AMP Questions for AEP Projects Presented at 11-3-2017 STEAC-Western Meeting

Hazard Station:

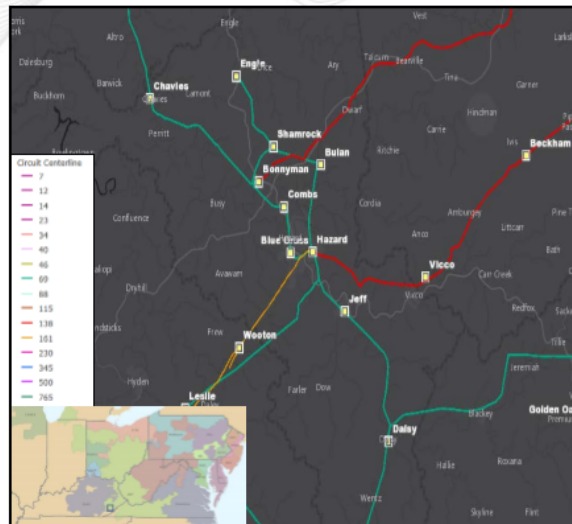
Q: Please provide a detailed breakdown of all condition issues for Hazard station.

Q: Circuit breaker M has very little detail describing its issues. Please provide more details about this circuit breaker that has led AEP to determine the breaker has reached its End of Life?

Q: Is breaker M fully depreciated?

Q: Transformer #1 & #2, Please provide details about how AEP quantifies the contributions from each of the items noted in AEP's justifications and how are these items prioritized against one another:
